WATERFRONT TRAIL

Background Material for Providing a Trail for the CKCB Madison Avenue Development
PLN 50958 Compiled by Charles Schmid, Chair, Waterfront Trail Committee *ceschmid@att.net*

Reference: Revised Notice of Application/Hearing/SEPA Comment Period PLN50958
SPR/SSDP/SVAR

FIGURE 1
List of Properties in Shoreline Area
 (Note: These are names of current commercial activities. Not owners.)

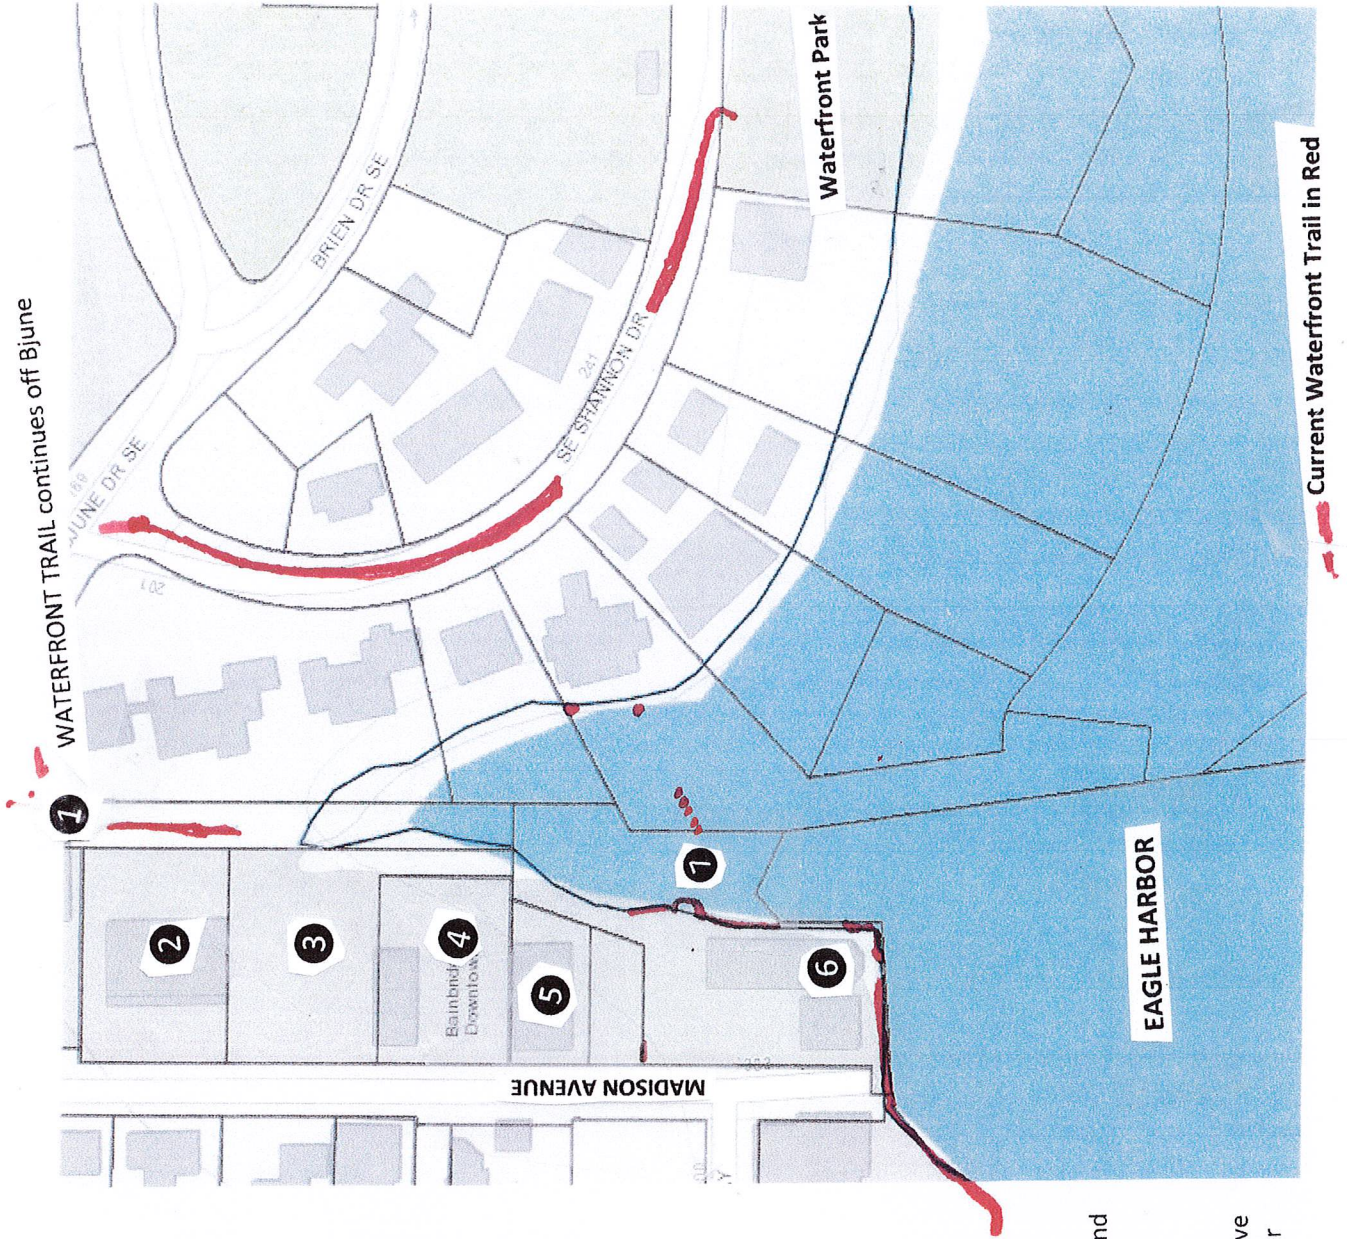
Figure 1 (Attached) shows the location of 6 properties which are all covered by the Shoreline Master Plan. Although this memo only covers locating the Trail on parcel number **3** (The proposed project), the completed trail might have to consider including a future easement in one of the other 5 properties. It is interesting to note that properties **3** and **7** have narrow appendages (called “flagpoles”) which actually adjoin each other. These initially appeared to provide a plan by which only the two flagpoles were needed, but a walk in the area shows some areas of the flagpoles appear too steep for a trail. Parcel **4** has concrete walls around its perimeter which formerly supported large fuel tanks. Parcel **6** presently has an easement all around it providing public views of the shoreline and harbor. A restaurant has tables set in the summer on that easement. Finally parcel **1** was planted with native vegetation a couple of decades ago and needs to be cleared. The south end of this COBI parcel is a storm water output with various data collection devices.

- 1 COBI Property/Sstormwater Line**
 Waterfront Trail over COBI stormwater line
 Connects at Bejune andnd continues adjacent to SeaBreeze. Stormwater exits at south end
- 2 Fairbanks Construction**
- 3 CKCB Madison Ave. Development**
 PLN50958 SPR/SSDP/SVAR
 Includes "flagpole" to south (in white)
- 4 Kelly Johnson Gallery
 Castellane Jewelry**
 Concrete foundations remain on property which once held large fuel tanks
- 5 Billy Sheers**
- 6 Waterfront Building**
 Thai Restaurant. Flagpole north connects to flagpole south. Waterfront Trail circles the building with public water visual access and continues west along water to Harbour Pub
- 7 Lost Easement**
 There was once an easement to Shannon Drive which was not recorded by Winslow and later removed. Attempts to renew it failed.
